Proceedings of the Madras Government, Public Works Department, 4th October 1864.

Read the following Circular from Colonel R. STRACHEY, R. E., Secretary to the Government of India, Public Works Department, dated Simla, 27th August 1864, No. 60.

Directs a modification in the steps of all Plunge-baths.

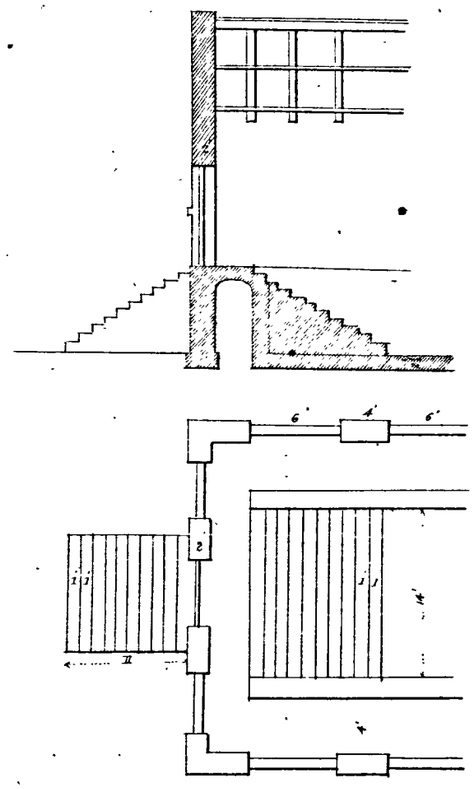
1. An accident, resulting in loss of life, having occurred in the Plunge-bath at Meean Meer, apparently resulting from the faulty construction of the steps, the Governor General in Council directs, that the steps of all Plunge-baths may be modified as shown in the margin, an arrangement which will be convenient for all parties, for those who can and those who cannot swim.

2. One-fourth of the bath at the end next to the steps should also be constructed so as not to be more than four feet deep for men who cannot swim. For the women's baths there should be a like arrangement.
